Interactive comment on “Technical note: Water table mapping accounting for river-aquifer connectivity and human pressure” by Mathias Maillot et al.

Mathias Maillot et al.

Received and published: 23 July 2019

Fig. 1. 2D cross-sections for profile 1 and profile 2. Profile 1 is always connected and profile 2 is always disconnected

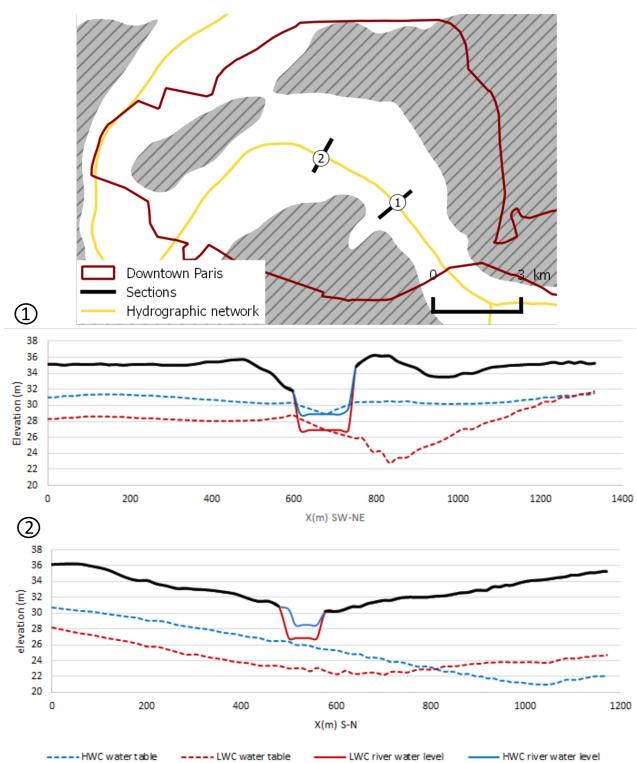
Figures: Could in general all be improved - very faint lines and symbols in particular. Figure 6a was interesting and should be complemented with similar 2D cross-sections when feasible to get an idea of the shape of the water table near the river.

The following illustration (Fig.1 of this answer) is an example of 2D cross sections of water table, river water level and topography. This figure shows the estimation of water table for LWC and HWC at connected and disconnected parts of the river. We think that this figure would bring redundant information with Fig.6 if included in the paper, this is why we would prefer not to do so.
